Subject: MHI's Second Responses to US-APWR DCD RAI No.39

**Second Responses to Request for Additional Information No.39
Revision 0**

US-APWR Design Certification

RAI NO.: NO.39-548 REVISION 0
SRP SECTION: 19 – Probabilistic Risk Assessment and Severe Accident Evaluation
APPLICATION SECTION: 19.1
DATE OF RAI ISSUE: 7/29/2008

Figure 1 Relationship of the elevations

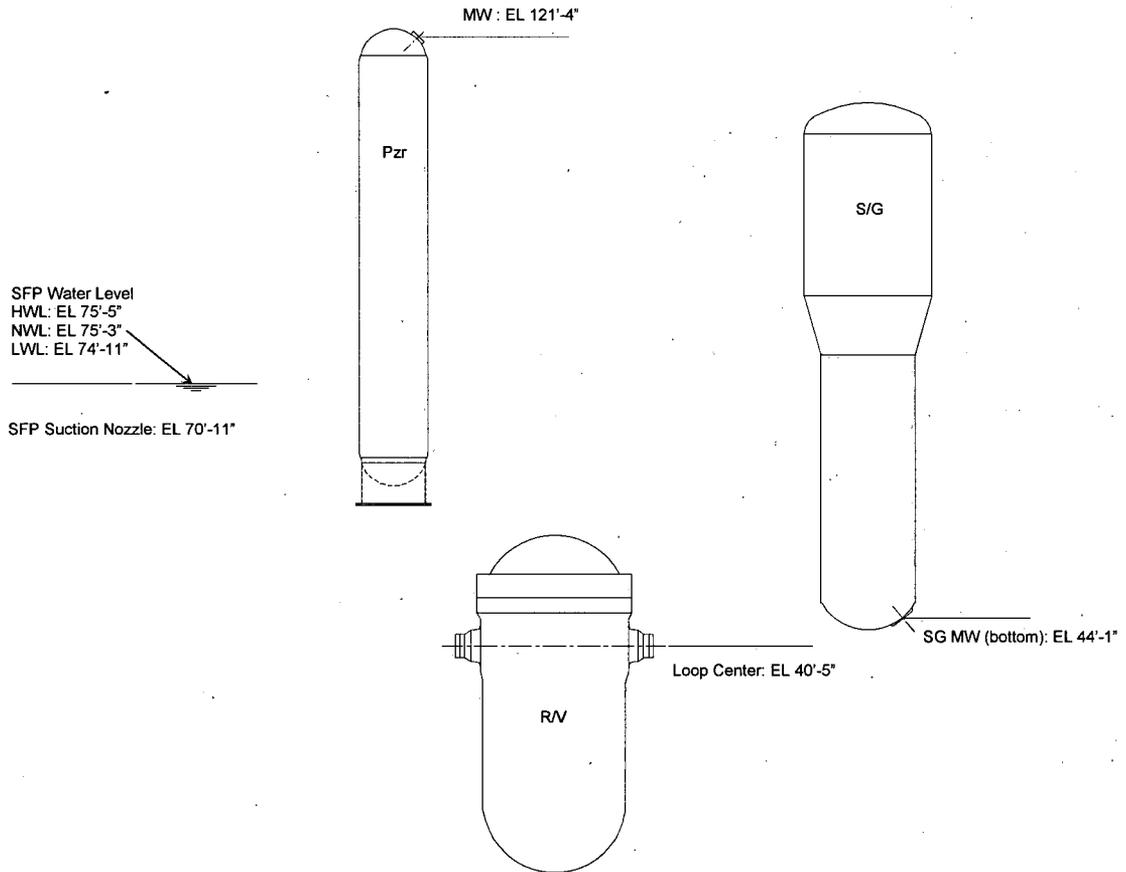
Gravity injection to the reactor coolant system (RCS) from the spent fuel pool (SFP) during shutdown is a mitigation strategy that is not typically seen for reactors in the United States. Overdraining the SFP could result in damage to the stored fuel. Remove discussion of this mitigation strategy and all credit in the shutdown probabilistic risk assessment (PRA), or provide the following information for the staff's evaluation: (a.) Detailed elevation drawings of the RCS and SFP, with the elevation of the high point vent (e.g., pressurizer manway) and expected equilibrium level clearly indicated (b.) Design features and associated inspections, test, analyses, and acceptance criteria (ITAAC) to ensure that the SFP cannot be drained to a level that would endanger the spent fuel (c.) Analysis results showing the gravity injection flow rate required to prevent boiling in the RCS (d.) Graphs of the driving head and gravity injection flow rate expected at various SFP levels (e.) Analysis of the consequences of overdraining the SFP (e.g., zirconium fire) (f.) Detailed procedural guidance for the evolution, including precautions and limitations provided to the operators (g.) Discussion of the controls to ensure that gravity injection does not occur inadvertently

(a) **Elevation of the RCS and SFP:** Relationship of the elevation of reactor vessel (R/V), steam generator (S/G), pressurizer (Pzr) and SFP water level is shown in Figure 1. SFP water level is sufficiently higher than the elevation of main coolant pipe (MCP) and SG manway to inject water to RCS by gravity as shown in Figure 1. Suction nozzle of SFP is located in the upper part of SFP to prevent the water below the suction nozzle from being drained.

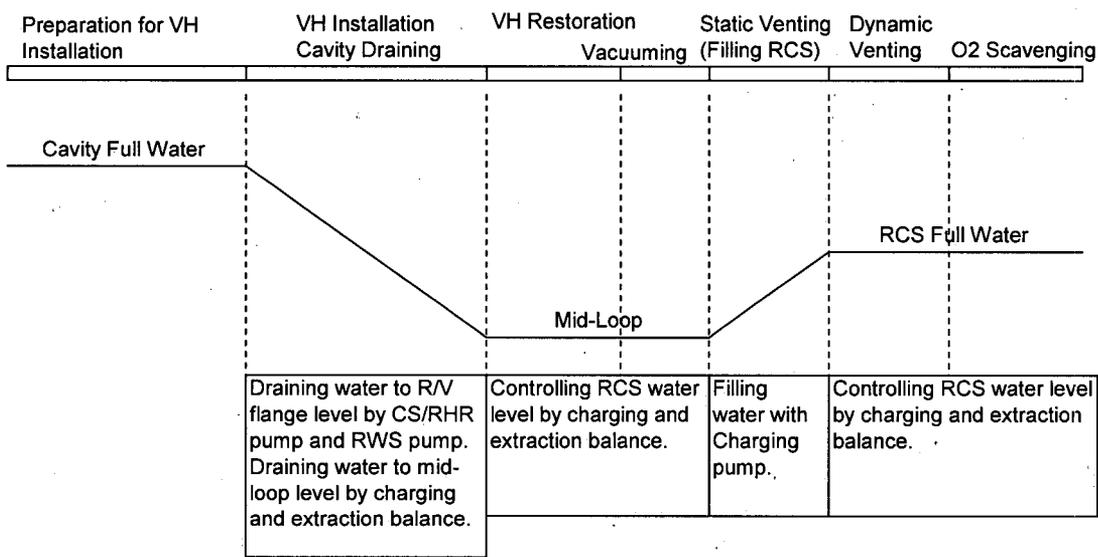
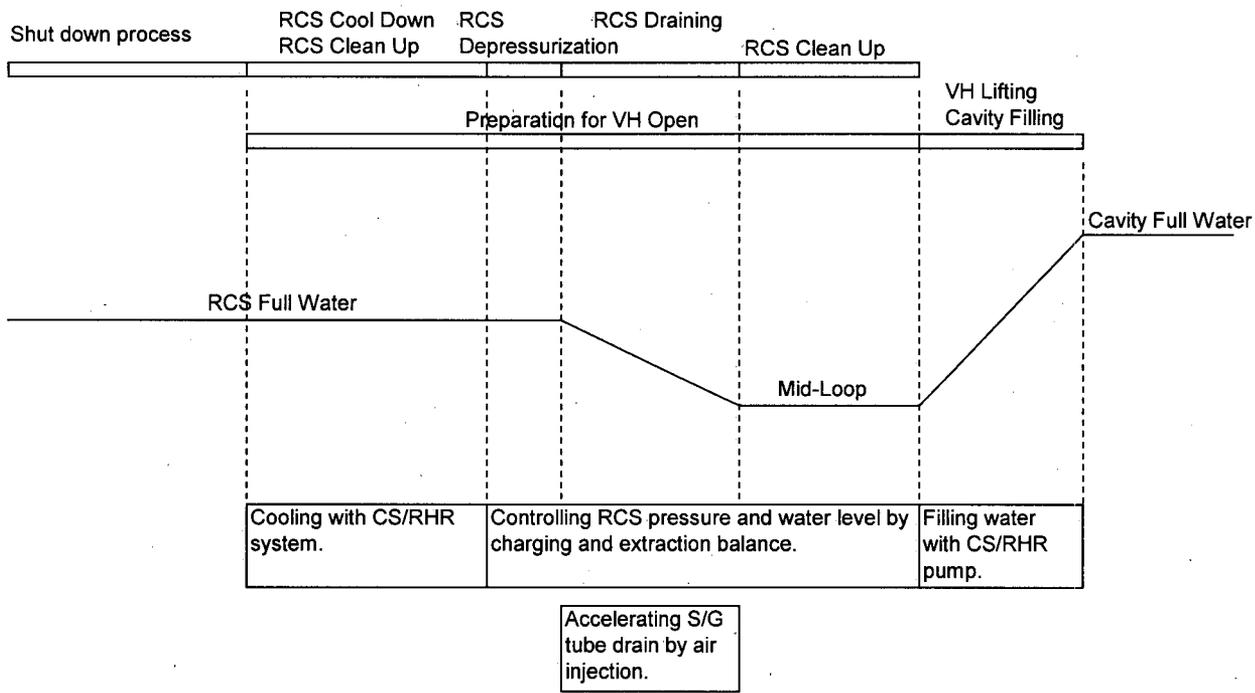
So that the staff can understand the US-APWR shutdown strategy, describe the expected shutdown sequence of events from entry into MODE 5 until the reactor cavity is flooded for refueling and during startup from the time when reactor cavity draining begins until entry into MODE 4. Describe the approach taken (e.g., tasks performed, systems and equipment used) for each step, including but not limited to:

- (a.) Depressurization before draining the RCS
 - (b.) Reduction of RCS level to mid-loop
 - (c.) Draining the steam generator tubes
 - (d.) Level control during mid-loop
 - (e.) Draining the refueling cavity after refueling
 - (f.) Vacuum fill of the RCS
-

Please see the following figures.
